TRANS/WP.29/868  
23 July 2002

DRAFT SUPPLEMENT 3 TO THE 01 SERIES  
OF AMENDMENTS TO REGULATION No. 21

(Interior fittings)

TYPICAL POSITION OF CYLINDRICAL TEST ROD IN THE OPENING ROOF AND WINDOW OPENINGS

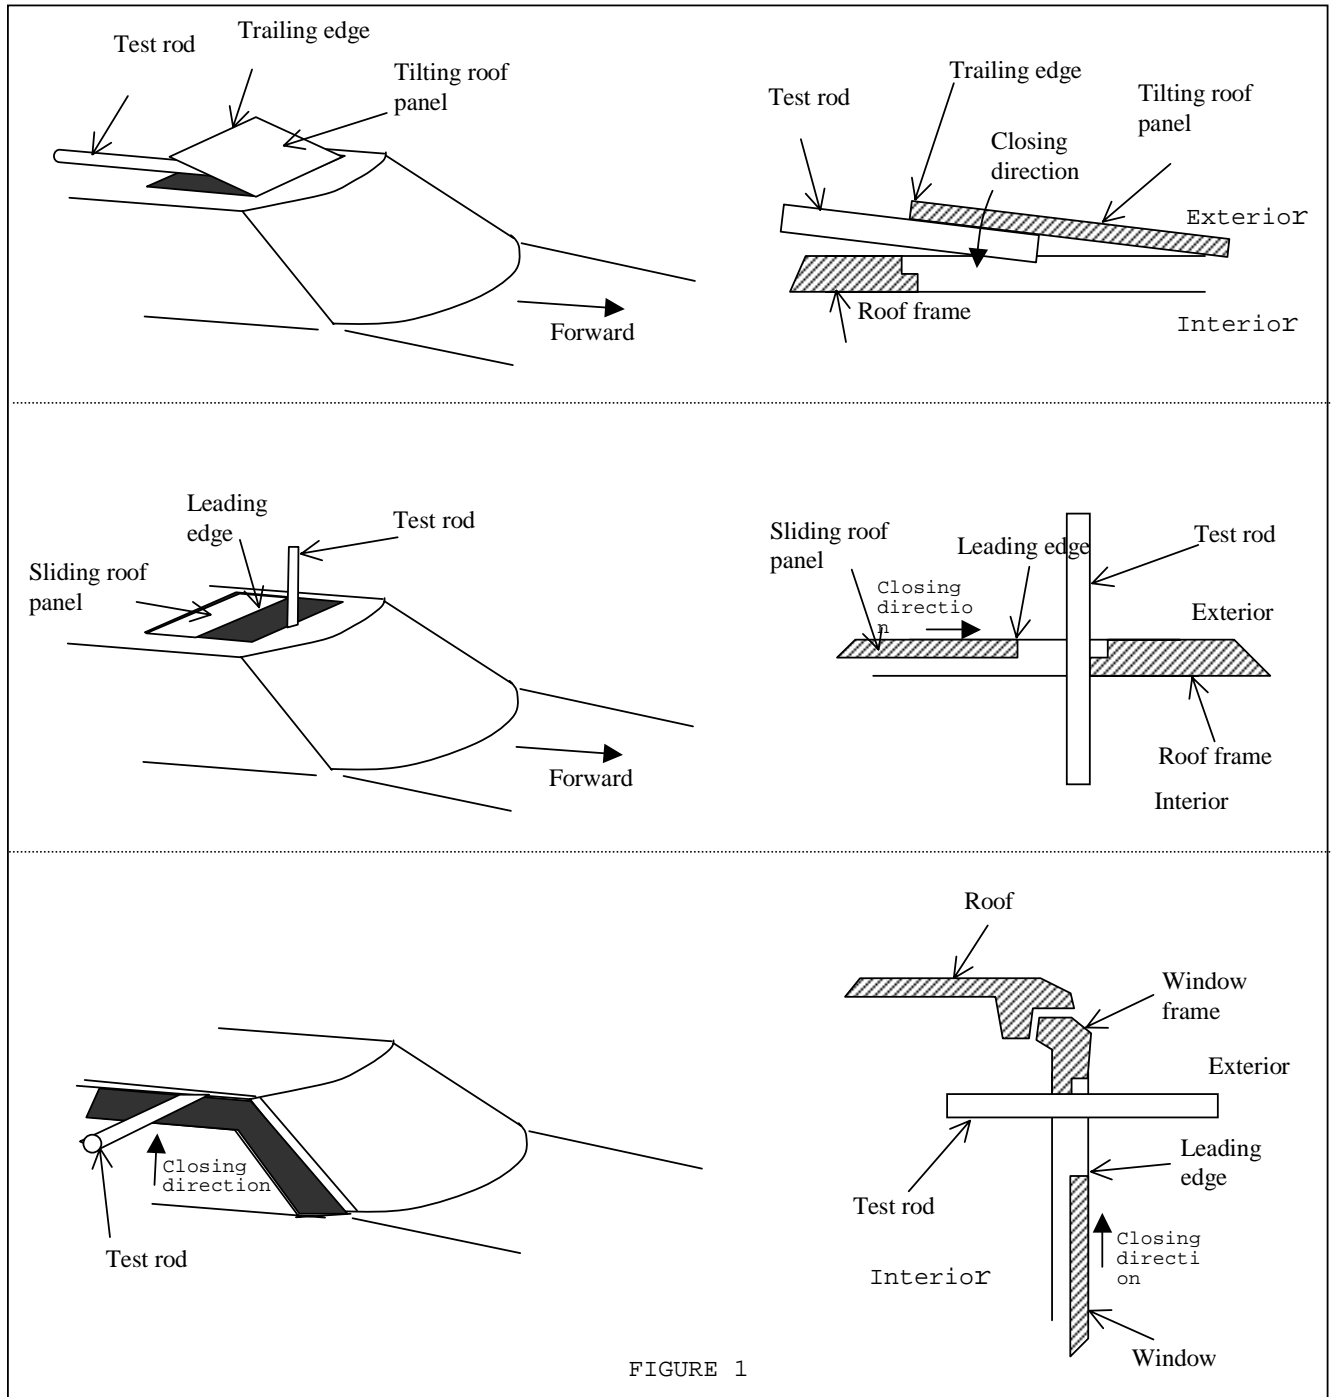
- 5.8.3.1.2.4. in the case of tilting motion of a roof panel, the maximum angular opening.
- 5.8.3.1.3. To check power-operated windows/roof-panel systems/partition systems with reversing devices as per paragraph 5.8.3.1.1., a measuring instrument/test rod shall be placed through the opening from the inside through to the exterior of the vehicle or, in the case of a partition system, from the rear part of the passenger compartment in such a way that the cylindrical surface of the rod contacts any part of the vehicle structure which forms the boundary of the window/roof-panel partition aperture. The force deflection ratio of the measuring instrument shall be  $10 \pm 0.5$  N/mm. The positions of the test rod (normally located perpendicular to the edge of the window/roof panel/partition and perpendicular to the closing direction) are illustrated in Figure 1 of annex 9 to this

Regulation. The position of the test rod relative to the edge and the closing direction shall be kept throughout the test.

FIGURE 2

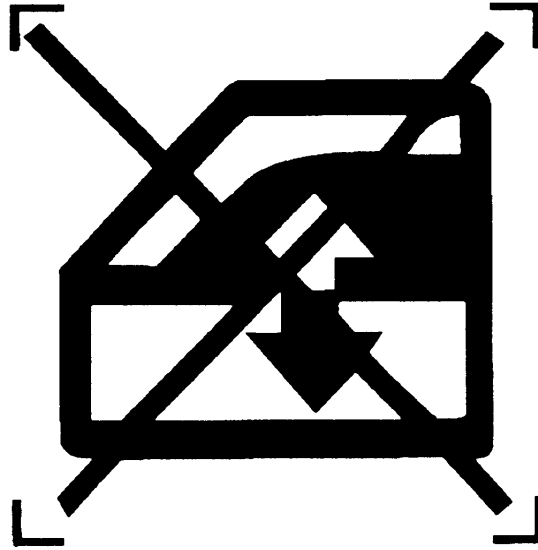
The driver-controlled switch shall be located so as to minimize any accidental manipulating. It shall be identified by the symbol shown in Figure 2 of annex 9 to this Regulation or an equivalent symbol, for example according to ISO 2575:1998 reproduced in figure 3 of annex 9 to this Regulation.

Paragraph 2.5.

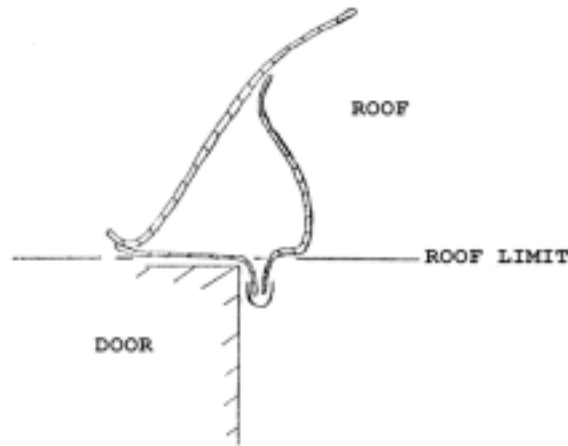
At the vehicle sides the roof shall commence at the upper edge of the door aperture. In the normal case, the lateral roof limits will be represented by the contours formed by the bottom edge (lateral view) of the remaining body when the door has been opened. In the case of windows, the lateral limitation of the roof will be the continuous transparent line (penetration point of the lateral windowpanes). At the posts, the lateral roof limitation will pass through the connecting line between the transparent lines. The definition of paragraph 2.5. is also valid for any opening for the roof, in the closed position, of a vehicle as defined in paragraphs 2.7. or 2.8. For measuring purposes, downward facing flanges shall be ignored. These will be considered as forming part of the vehicle sidewall.

Paragraph 5.1.1.

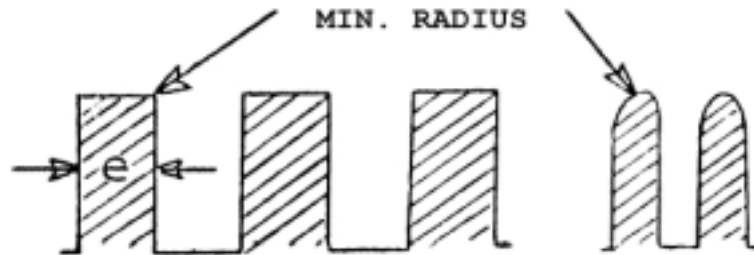
Grills are considered to comply with the regulations if they meet the minimum requirements of the following table:

Gap between elements [mm]	Flat elements		Rounded elements
	e/min. [mm]	min. radius [mm]	min. radius [mm]
0 - 10	1.5	0.25	0.5
10 - 15	2.0	0.33	0.75
15 - 20	3.0	0.50	1.25

Paragraph 5.1.5.

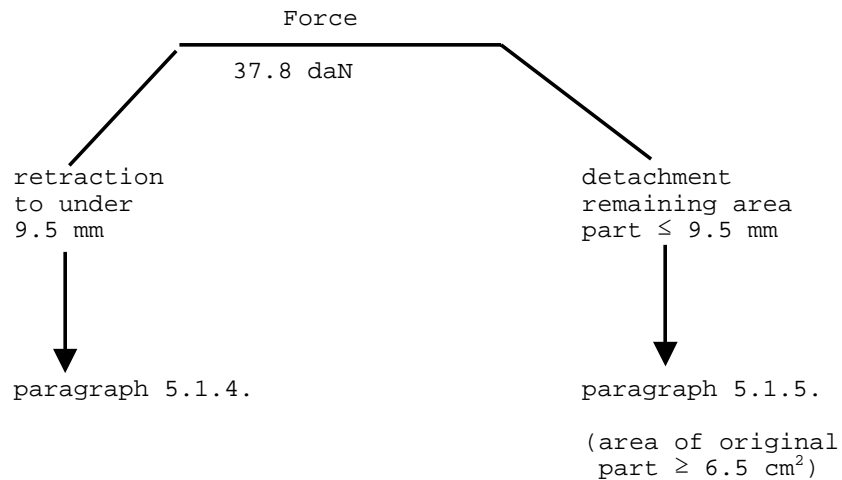
Paragraphs 5.1.4. and 5.1.5. complement each other; the first sentence of paragraph 5.1.5. (i.e. a force of 37.8 daN for retraction or detachment) is applied and then paragraph 5.1.4. in case of retraction up to a protrusion between 3.2 and 9.5 mm or, in the case of detachment, the two last sentences of paragraph 5.1.5. (the cross-section area is measured before the force is applied). However, if, under practical circumstances paragraph 5.1.4. must be applied (retraction to under 9.5 mm and over 3.2 mm) it could be more convenient, at the manufacturer' s discretion, to verify the specifications of paragraph 5.1.4. before applying the force of 37.8 daN specified in paragraph 5.1.5.
